Docket Number:	21-ESR-01
Project Title:	Energy System Reliability
TN #:	241251
Document Title:	Steve Uhler Comments Re Questions about analysis methods
Description:	N/A
Filer:	System
Organization:	Steve Uhler
Submitter Role:	Public
Submission Date:	1/21/2022 5:56:22 AM
Docketed Date:	1/21/2022

ESR-21-01 Questions about analysis methods

Reliability Analysis Over Different Planning Horizons

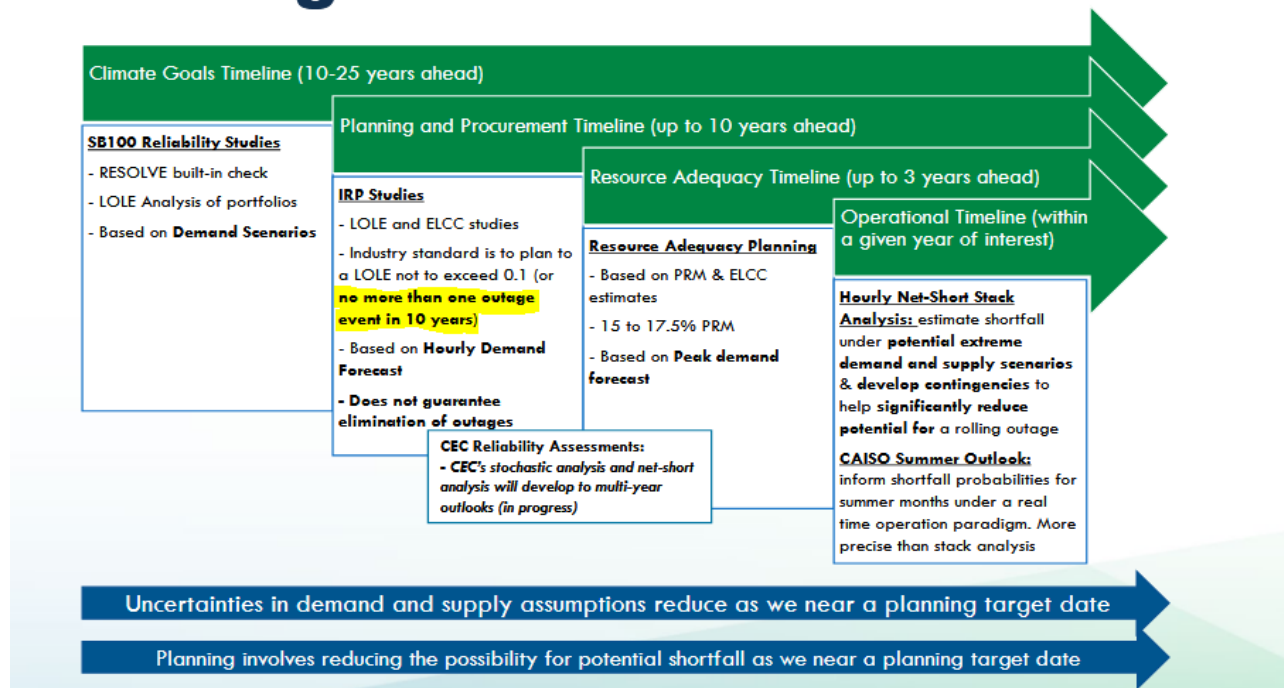
Please provide the logic and computational methods for loss of load expectation (LOLE) used in the reliability analysis. Based on the slide below from the [January 14, 2022 presentation](#), you are using an industry standard of no more than one outage event in 10 years.

This use of LOLE differs from North American Electric Reliability Corporation (NERC) use of LOLE found on [PDF page 236 of Probabilistic Fundamentals Workshop Course Materials December 2017-1.pdf](#).
